Metropolitan Development Commission Regional Center Hearing Examiner (October 23, 2025) Meeting Agenda

STAFF REPORT

REGIONAL CENTER HEARING EXAMINER - HIGH IMPACT CASE

| Case Number | 2025-REG-010 |

Site Plan, file-dated 6/4/2025

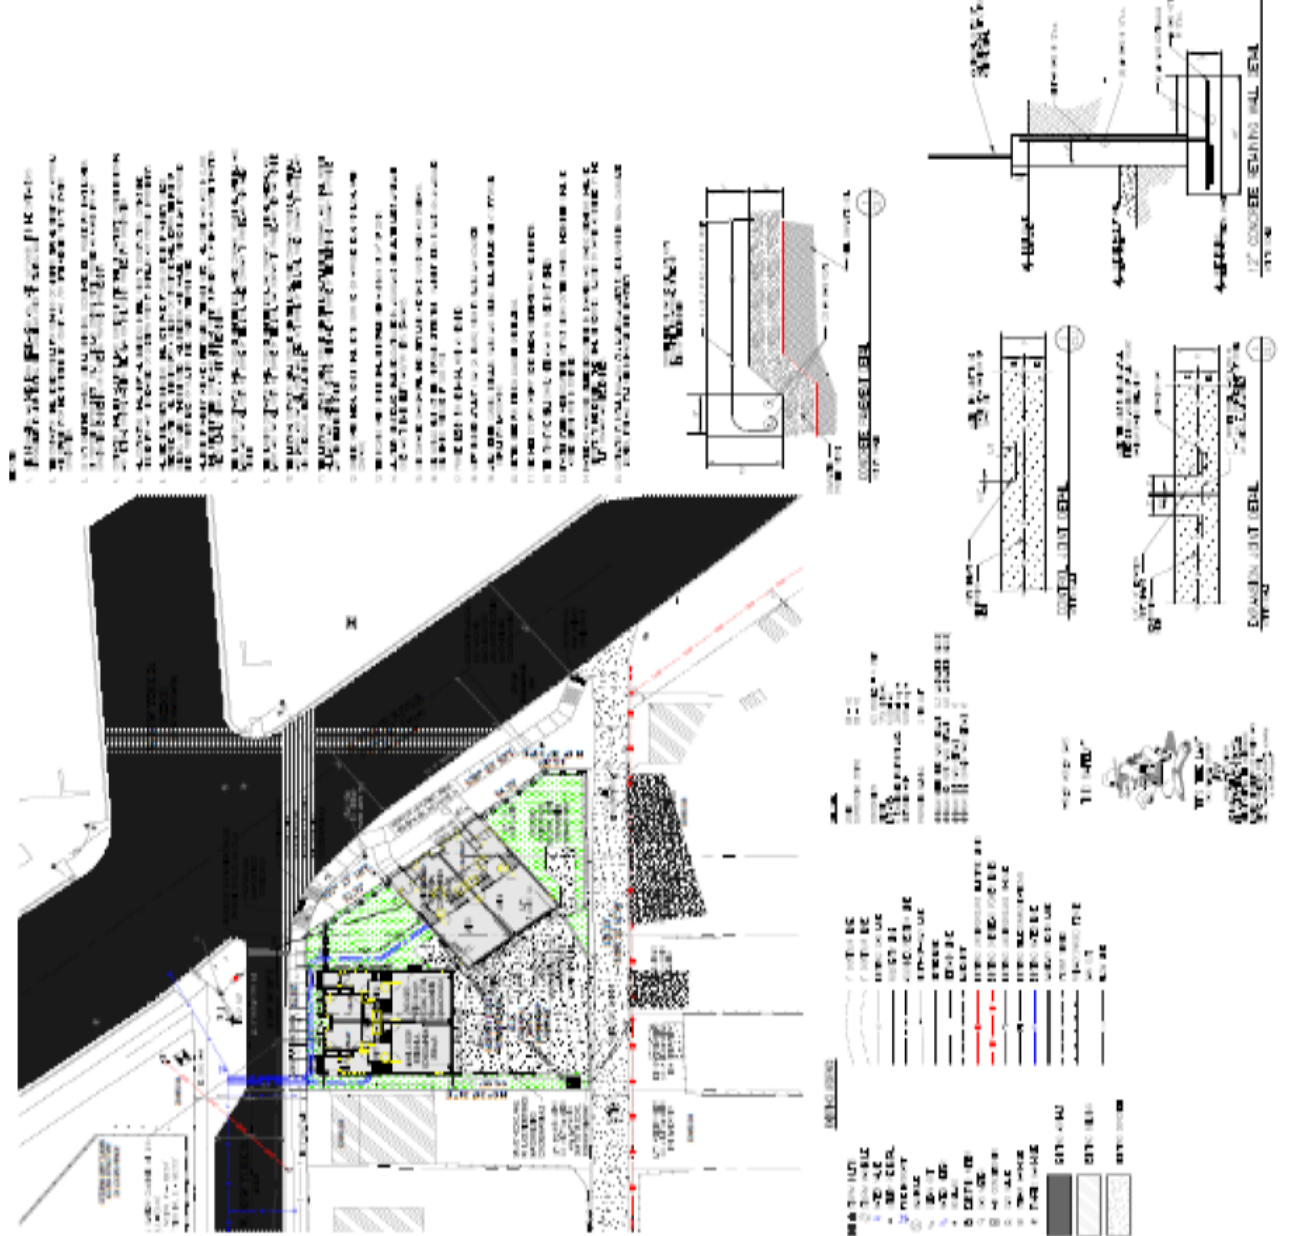
Revisions made by the petitioner now show the structures containing three (3) stories as opposed to the original four (4), and show the height of the structures to be just below 40 feet, measured from grade-level of the front façade to the top of the separation wall on the roof. Revised elevations, floor plans, and aerial views have been added to the staff report.

The variance petition seeks relief from the maximum height limit and reduced living landscape material on the front yard. The development would provide for two buildings, each with two townhomes, with a 45-foot building height and for the overall development comprising of 27% of living landscape material.

The site would be accessed from an alley to the south. There would be double-sized garages for each of the four units. Landscaping would be present in front of the buildings, in between buildings and to either side of the buildings. There would be two common patio amenity areas for the residents and guests. Each unit would include outdoor rooftop space, facing White River and downtown.

21V GROUND FLOOR
21 VIRGINIA MIXED-USE REGIONAL CENTER FILING
3 OCTOBER 2025

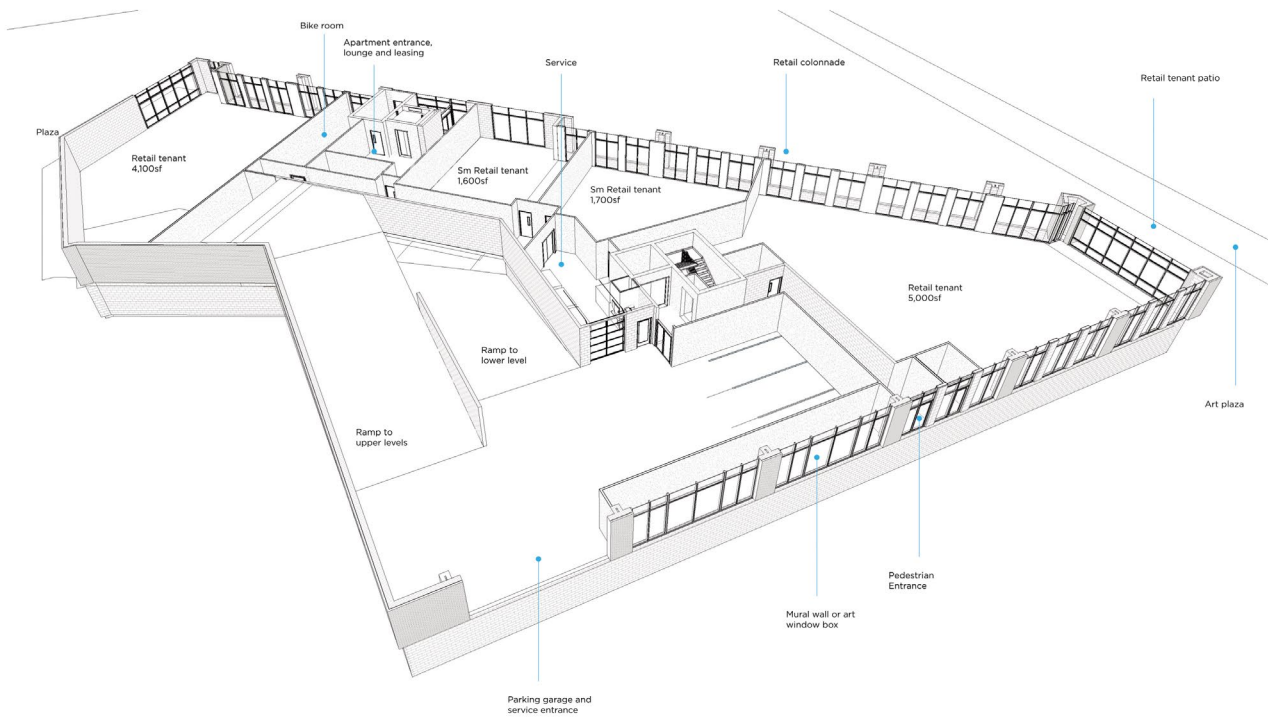
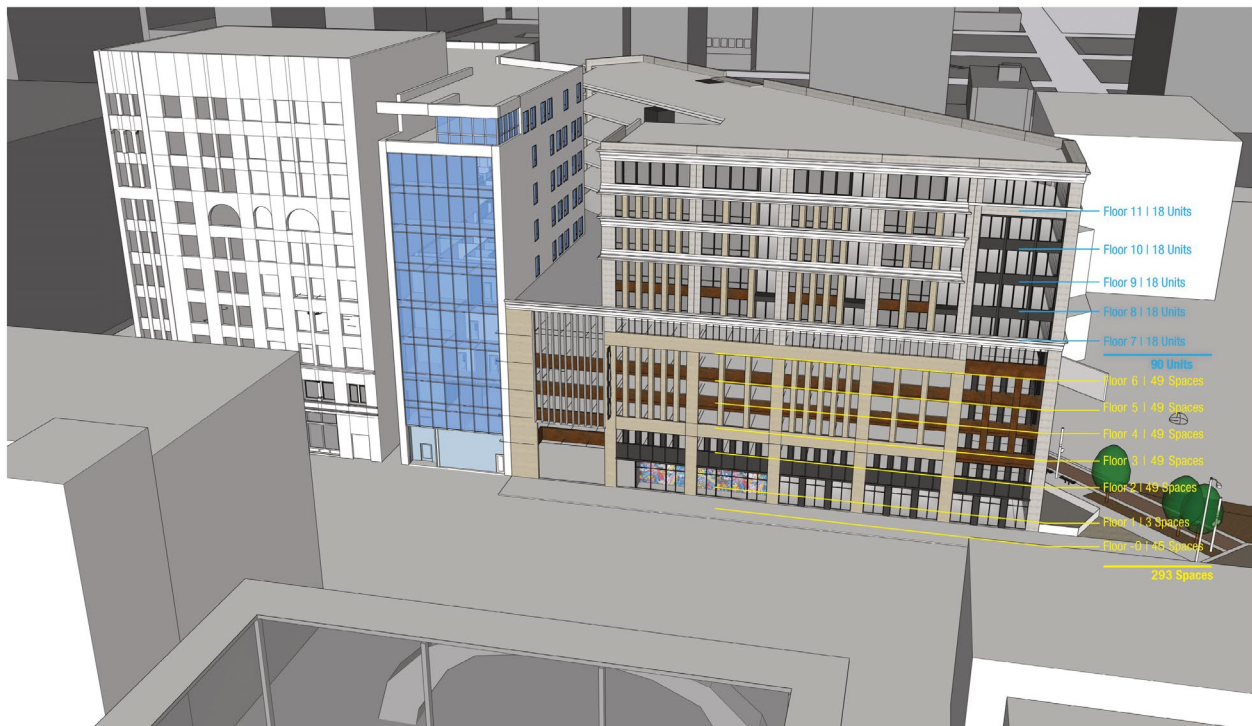
Staff expressed concerns with a second parking garage access location along Virginia Ave and the Indianapolis Cultural Trail, which would have created a conflict point between Cultural Trail users and vehicular access to the garage.

Revised plans filed on October 7, 2025 and elevations filed on October 9, 2025 indicated the removal of the parking garage access on Virginia Ave and the addition of a fifth floor of residential units. Staff finds the revisions to indicate a more productive use and a design that is better aligned with the site’s urban context. The increased residential use and singular access to the parking structure is a substantial improvement from the original plans.

Staff maintains their request for appropriate architectural screening of the parking garage where it is exposed to the public right-of-way.
